Product Change Notice (PCN)

Subject: Metal Spin and Change in RDL Design and PI Materials

Publication Date: 6/16/2023

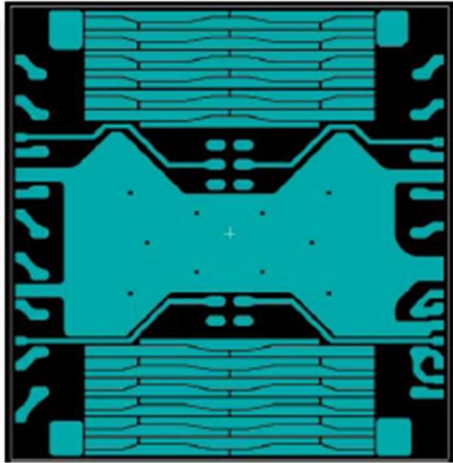
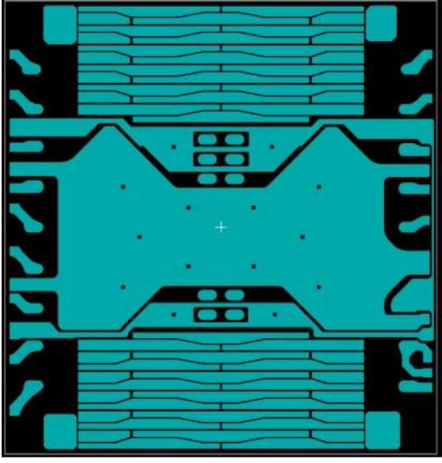
Renesas has made a metal spin to fix the ADC stuck and I2C issue. In addition, there are modifications made on the RDL layout and PI materials.

Current	New
Ordering Part#	P8900-X0Z001FNG P8900-X0Z001FNG8	P8900-X1Z001FNG P8900-X1Z001FNG8
RDL Design		
PI1 & PI2 Material	High temp cure material, HD4100	Low temp cure material, LTC9320
